Great Lakes UK Limited
Great Wolf Lodge, Chesterton, Bicester

Non Material Amendment (S.96a) Application
Design Changes

March 2023

Proposed Amended Scheme - Basement Plan

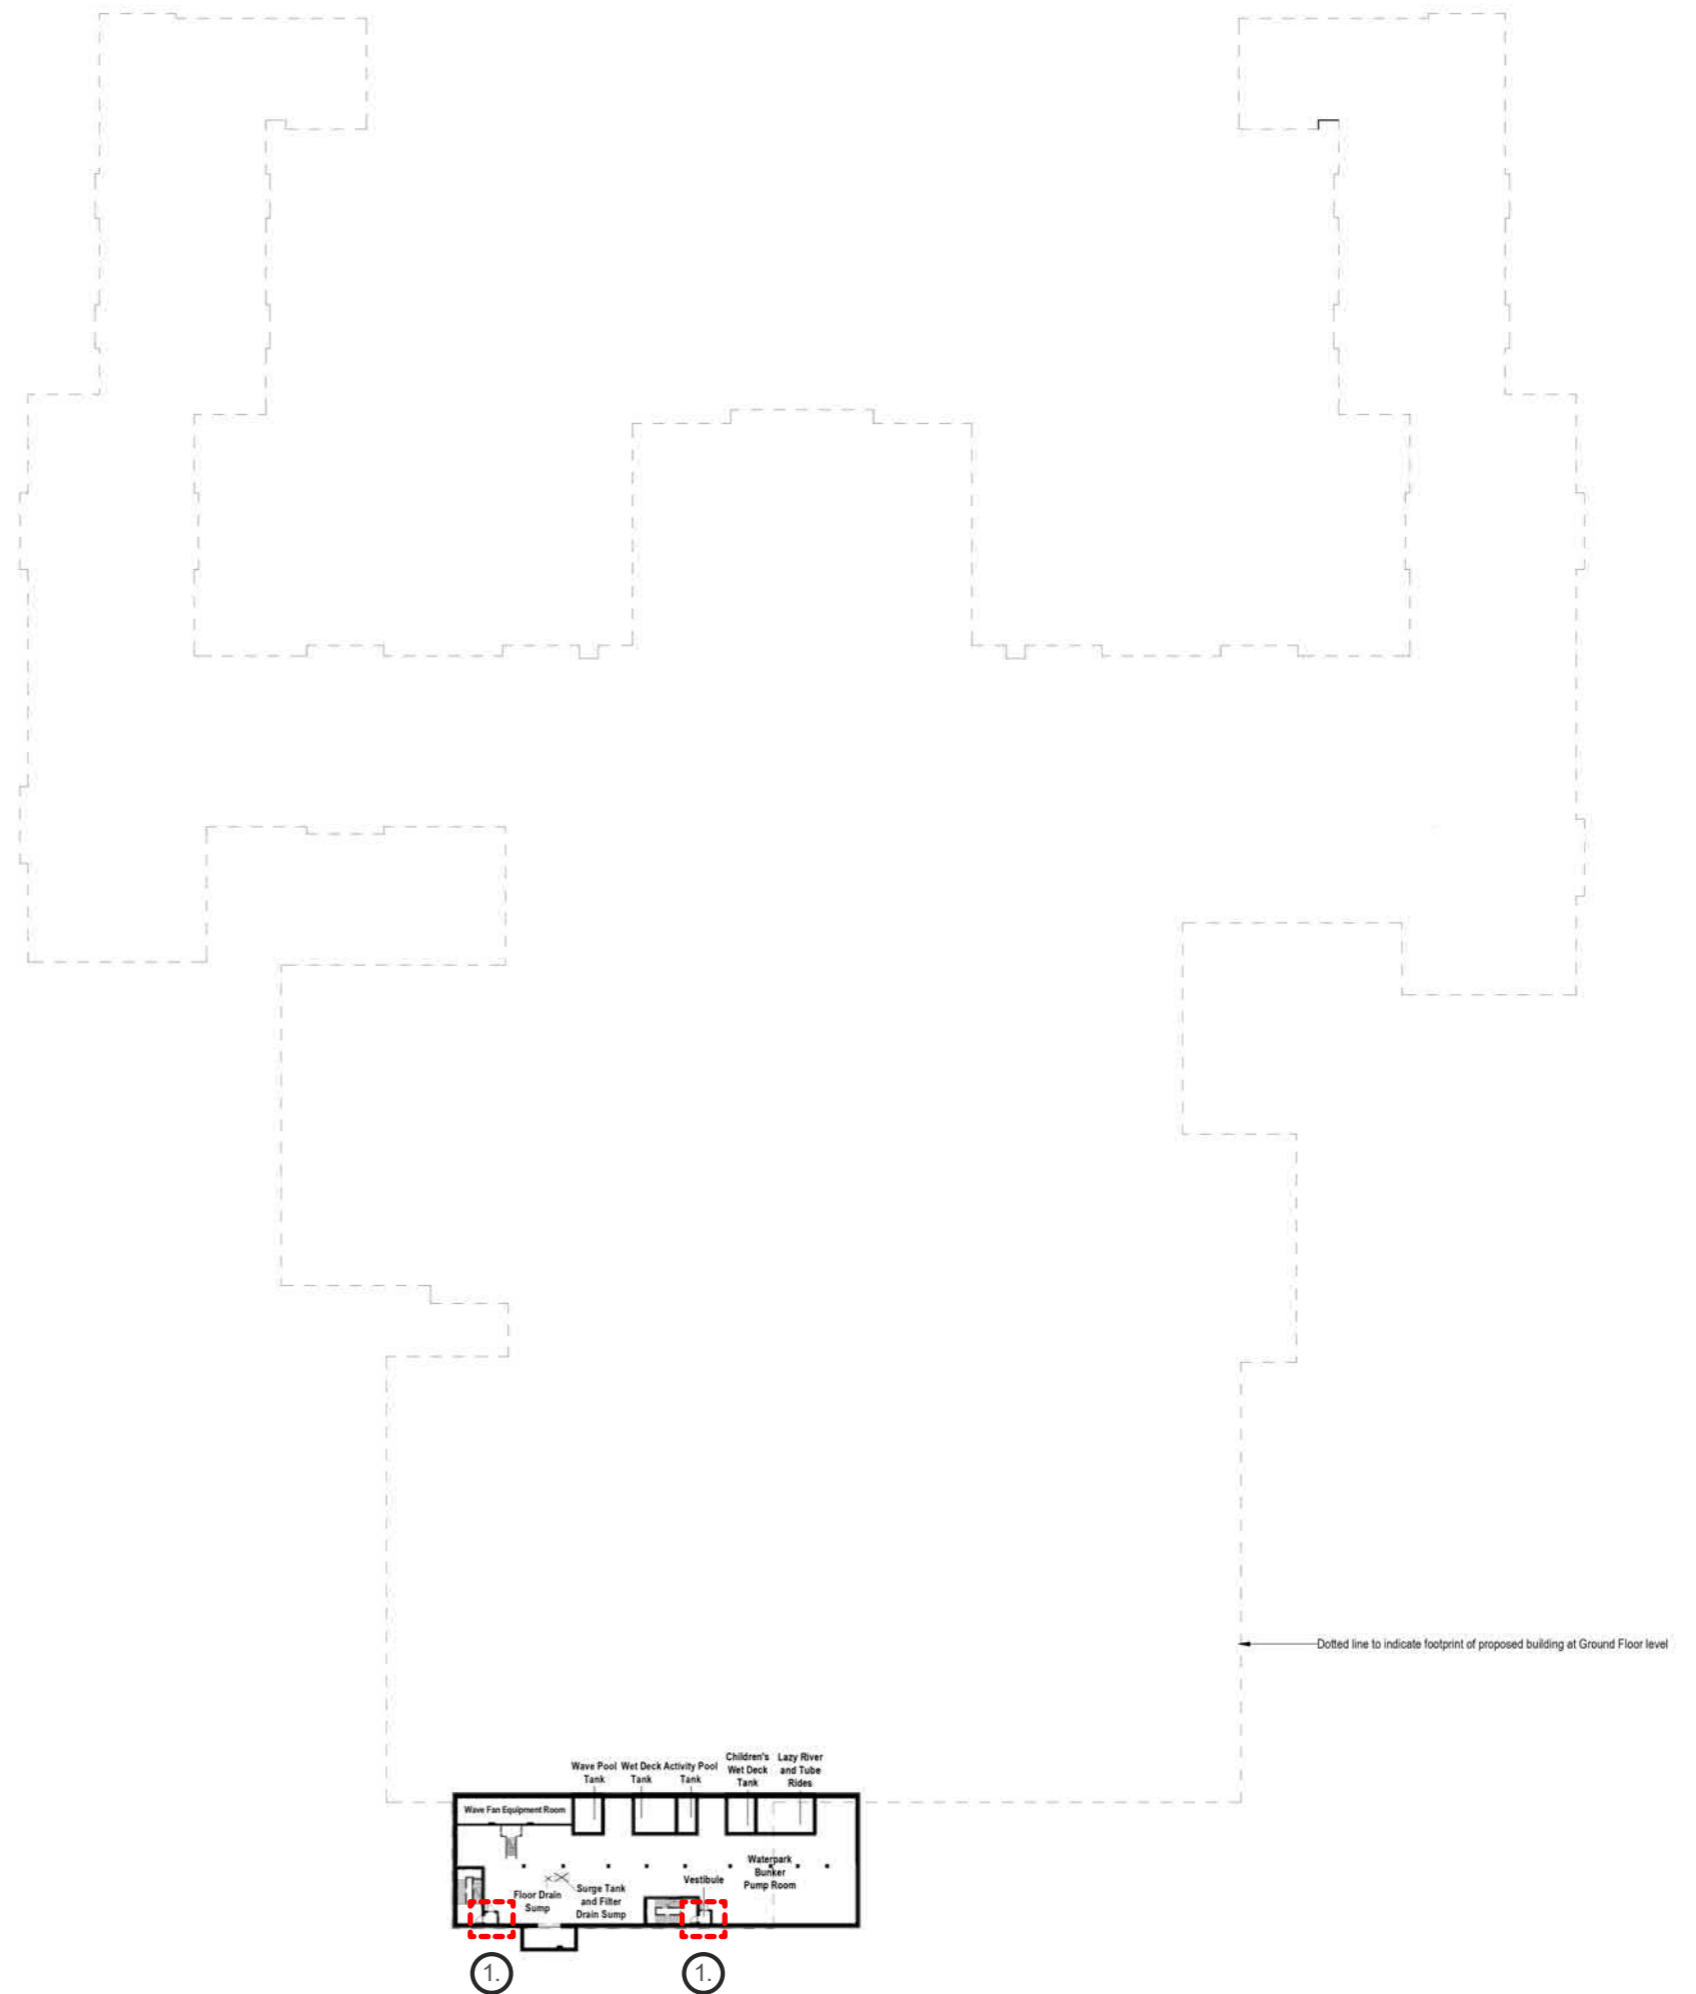
- 1. Lobbies to stair wells added for fire strategy compliance.

2.2 Scheme Changes Update Proposed Amended Scheme - Ground Floor

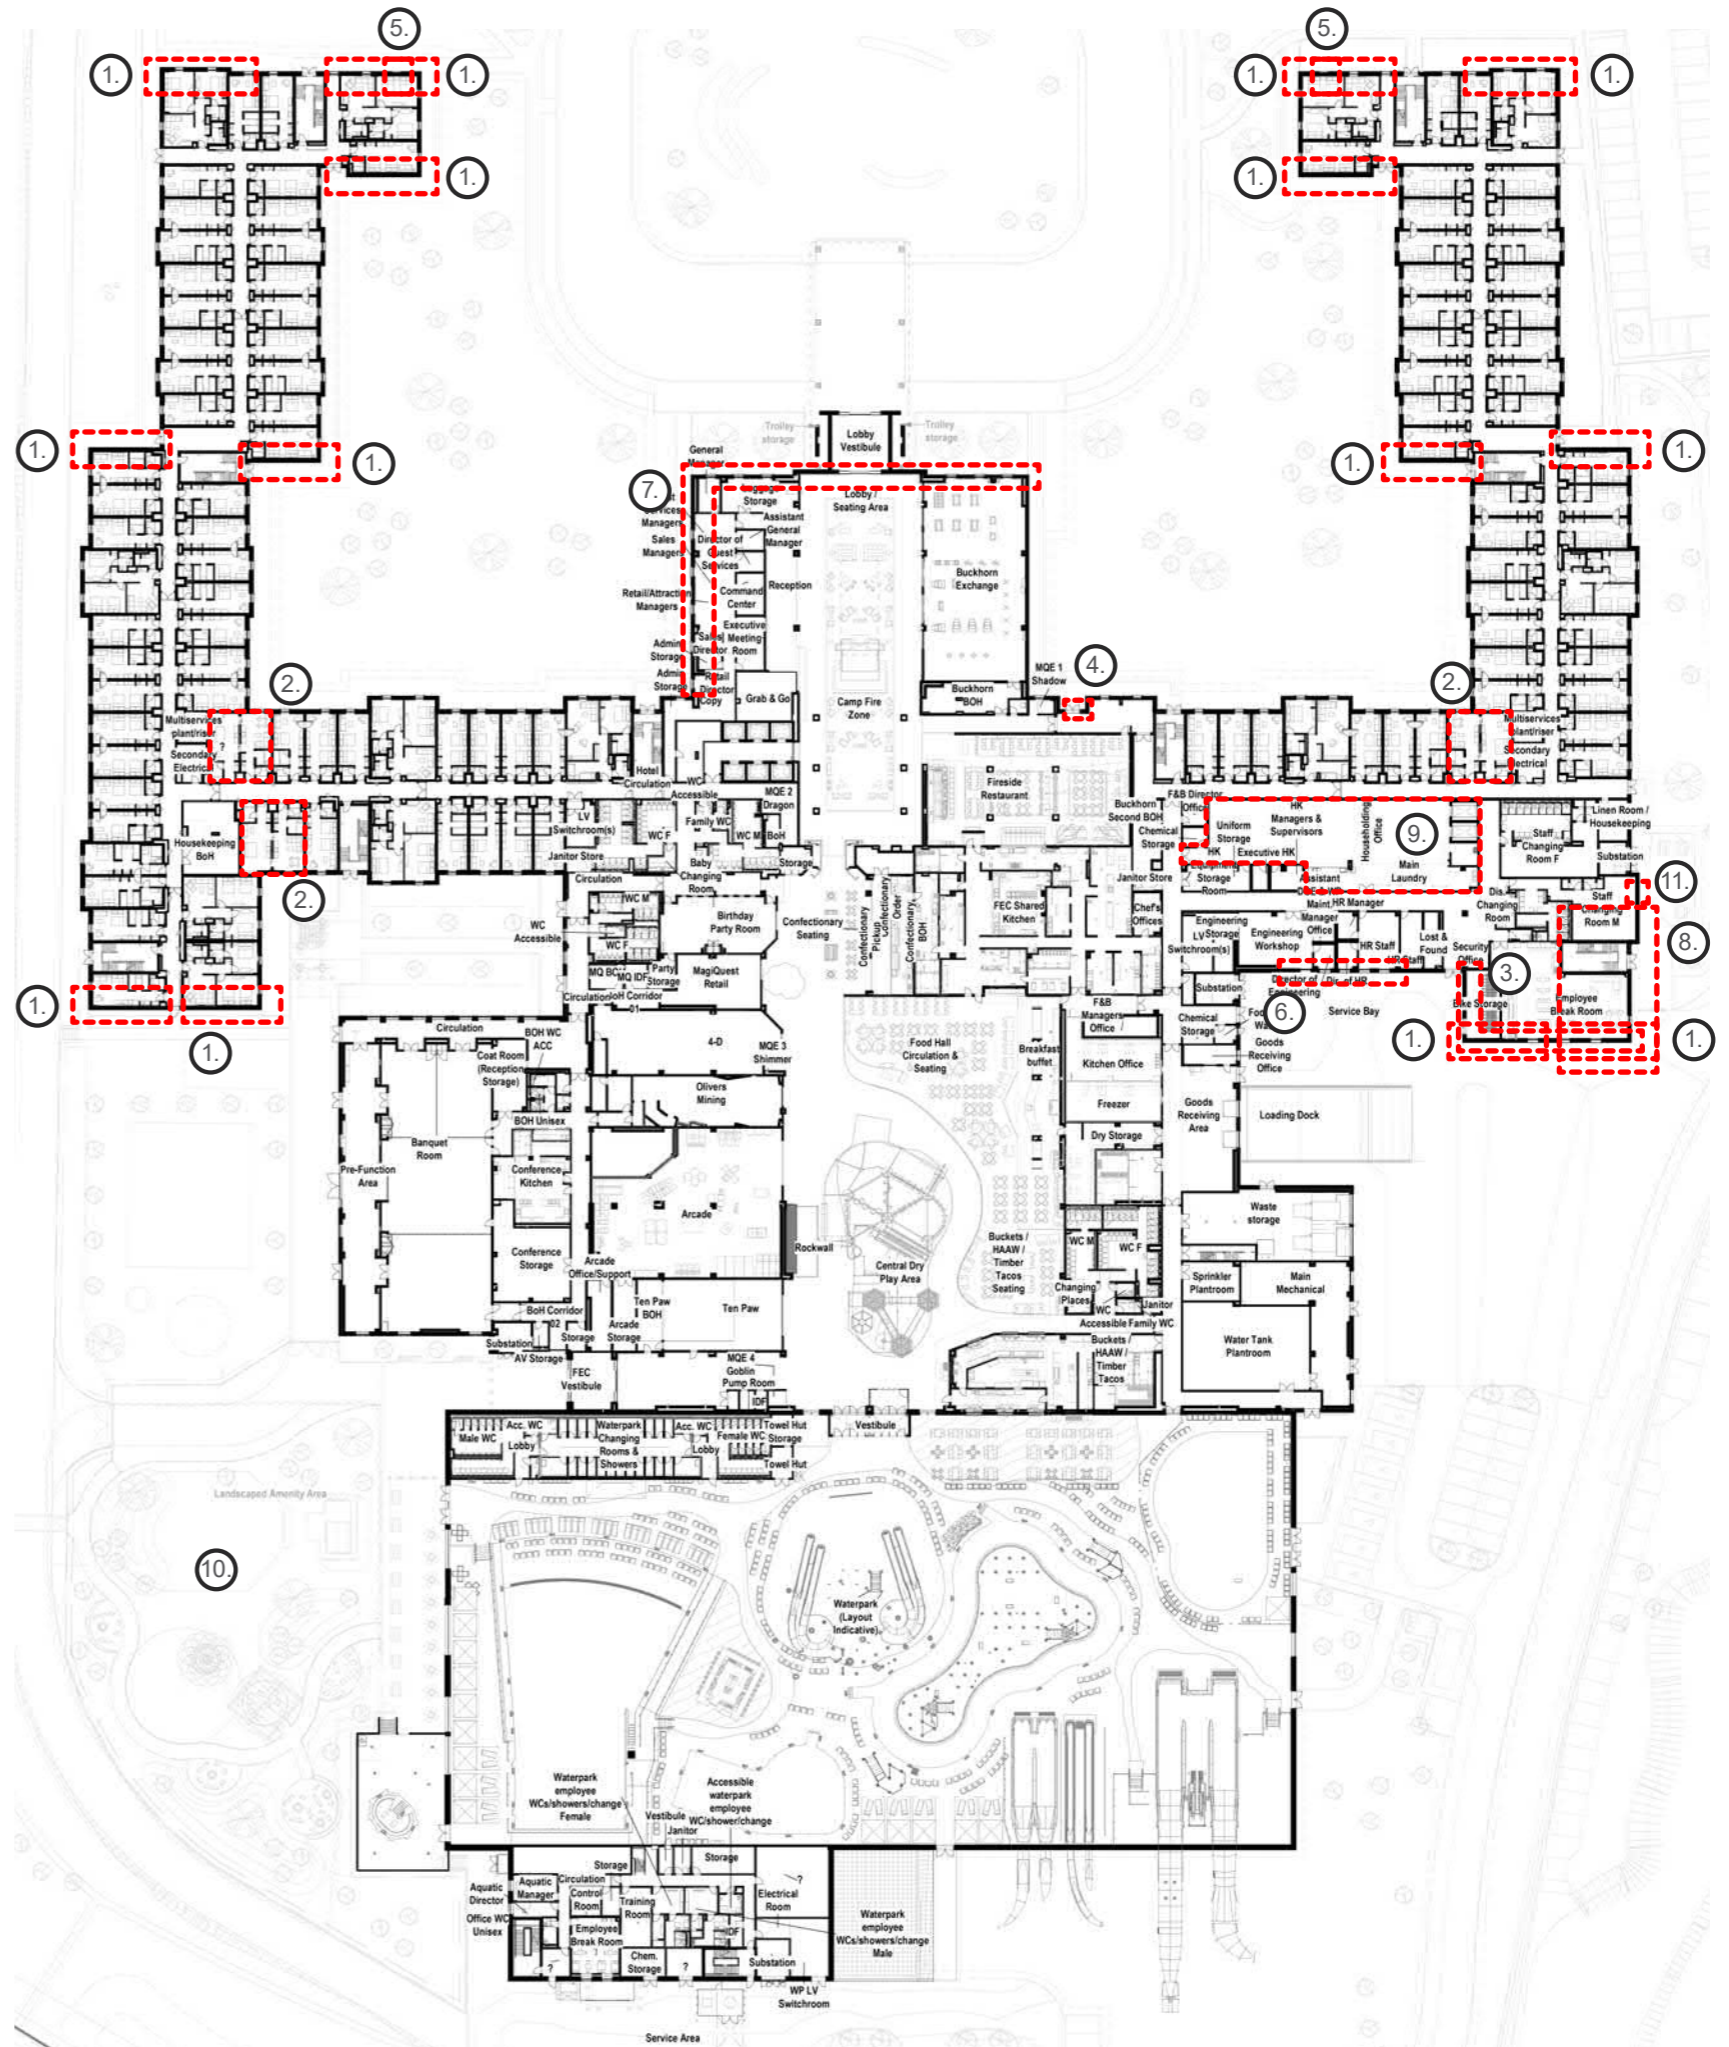
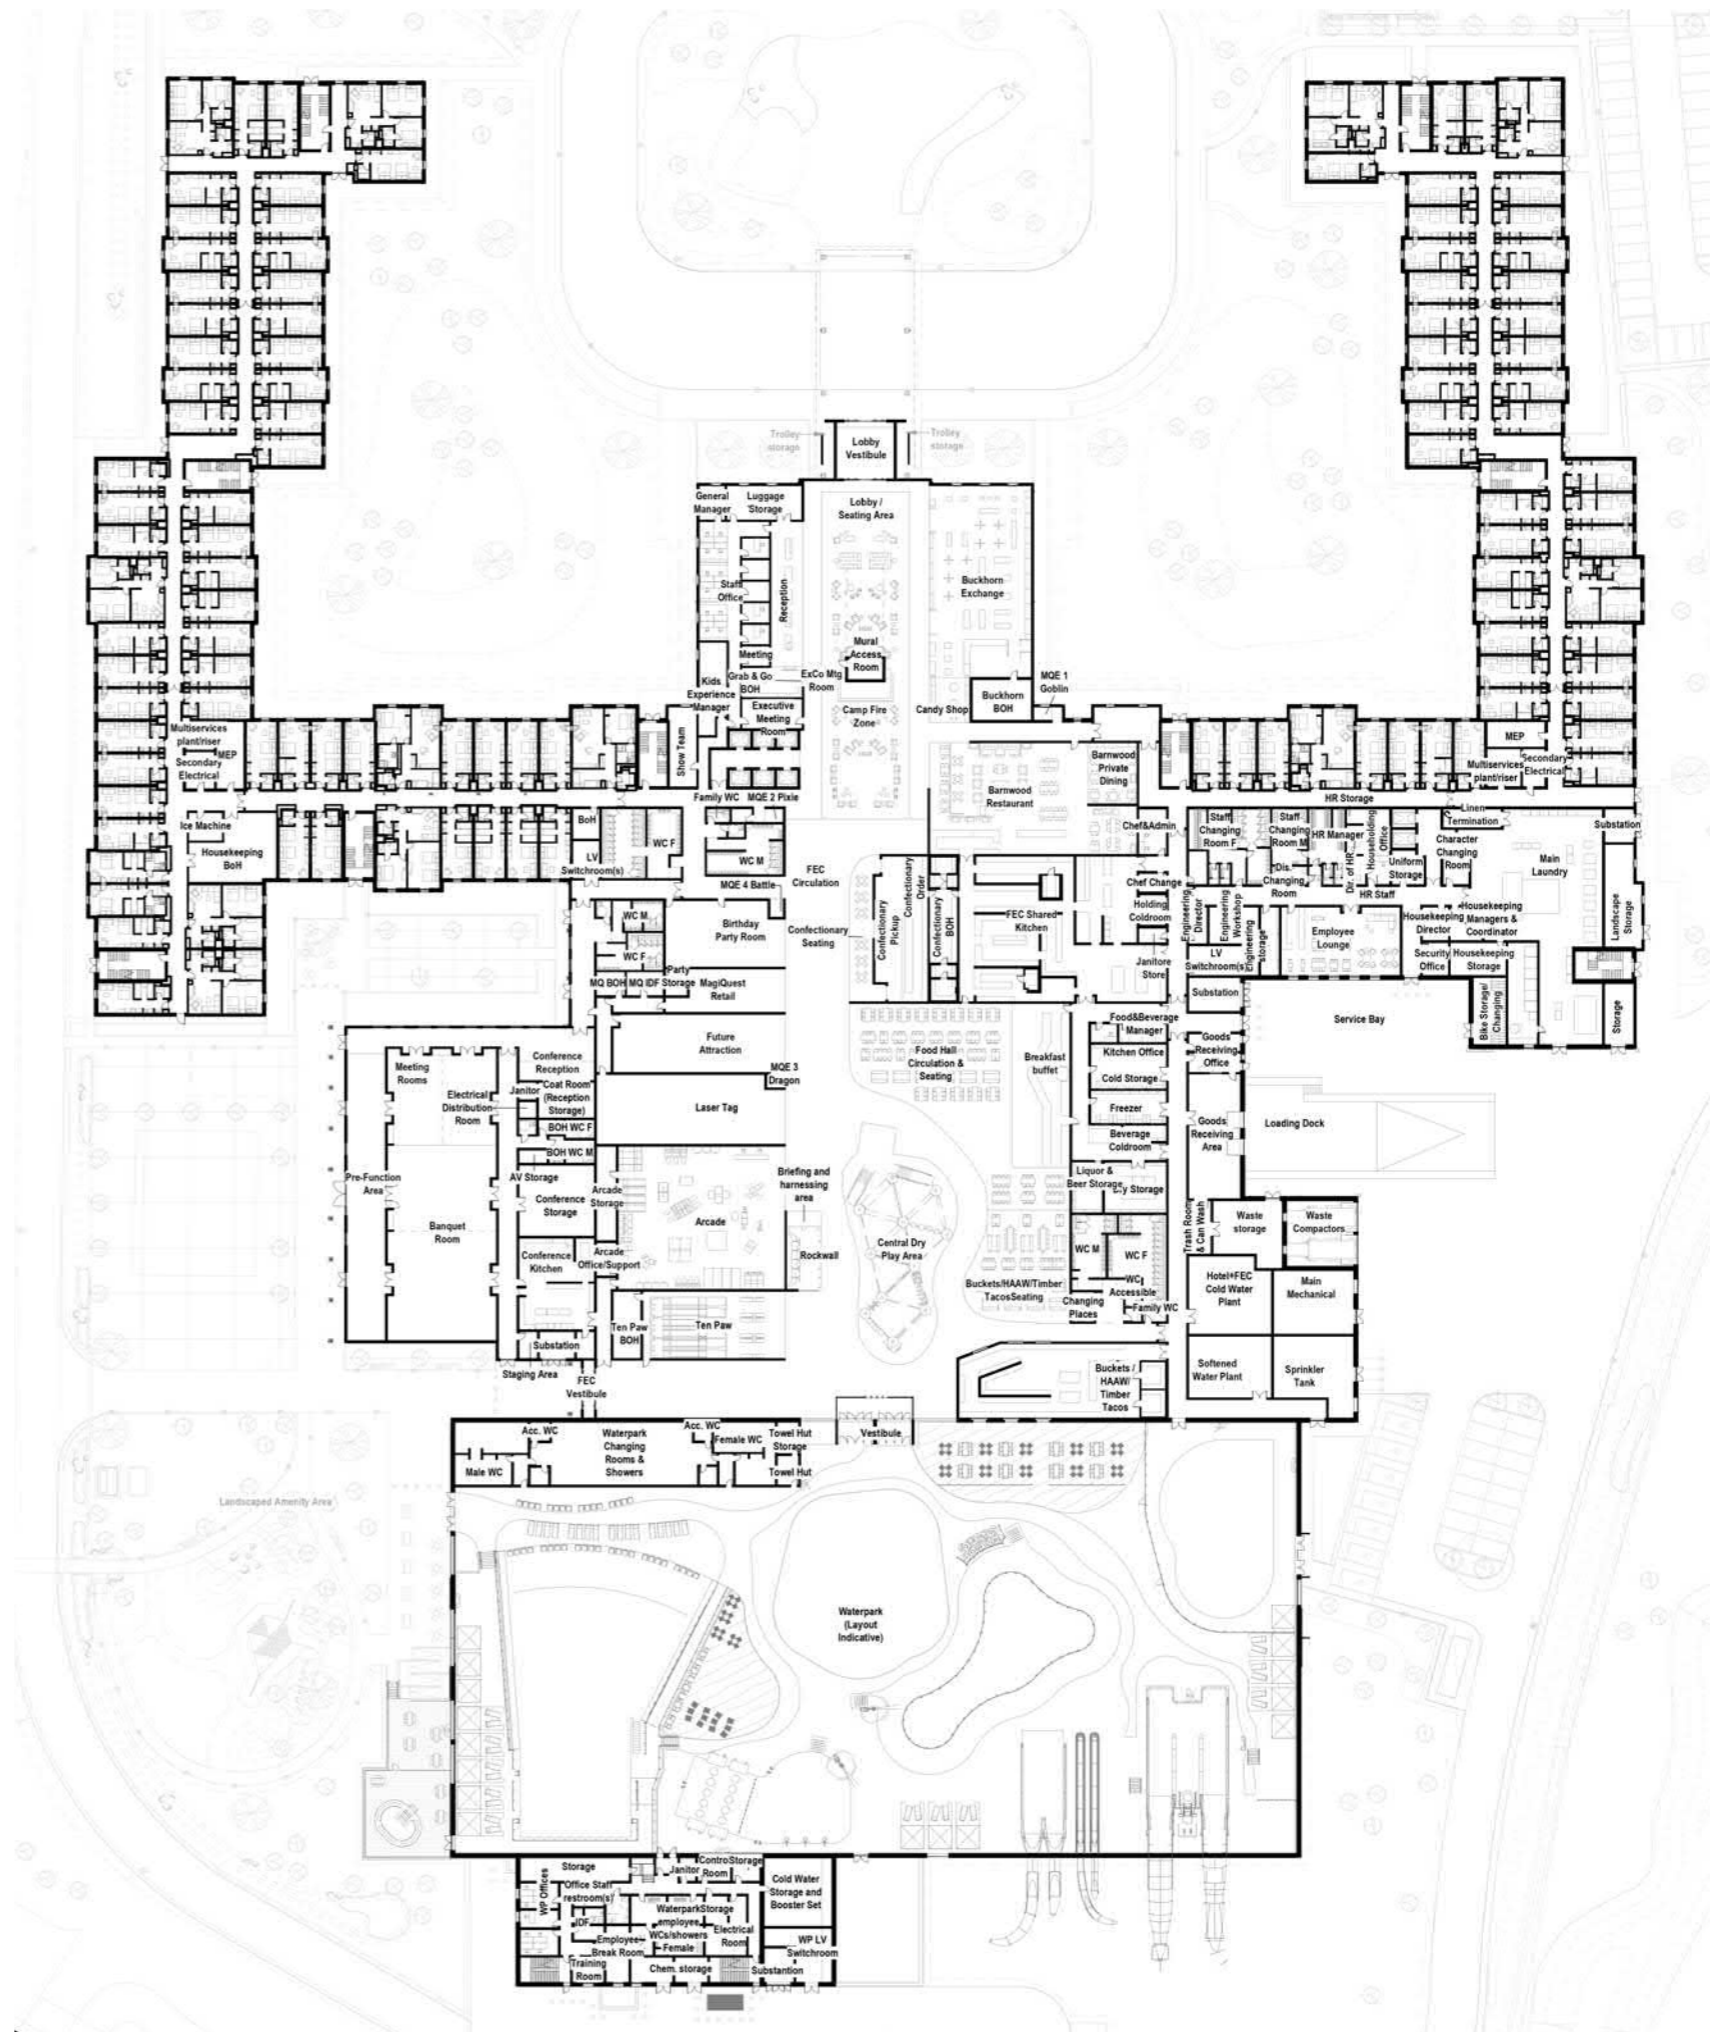
- ① Facades pushed out to allow columns not to protrude into guestrooms.
- ② Corner guestrooms changed to new enlarged types on every floor. 12 no. total rooms affected but no increase in room numbers with this change and no facade changes.

- ③ Updated materials on corner of building to enable better corner construction of materials and finishing. Render and brick now continues to building edge.

- ④ Door to ground floor added for fire escape.
- ⑤ Replace windows in corner rooms (where there were two windows in room) to recessed reveal detail.
- ⑥ Main BOH windows setting out change to suit internal layout changes.

- ⑦ Windows lowered around the Buckhorn and the BOH offices near the porte cochere.
- ⑧ Omission of the landscape storage unit and associated door. Omission of doors from wall facing service yard.

- ⑨ Changes to laundry strategy.
- ⑩ Changes to the landscape design.
 - 1. Access ramp to hot tub area omitted in lieu of platform lift
 - 2. Changes to access paths around the building perimeter

- 3. FEC amenity area changed from play space to seating areas
- ⑪ Omission of window to staff changing room.
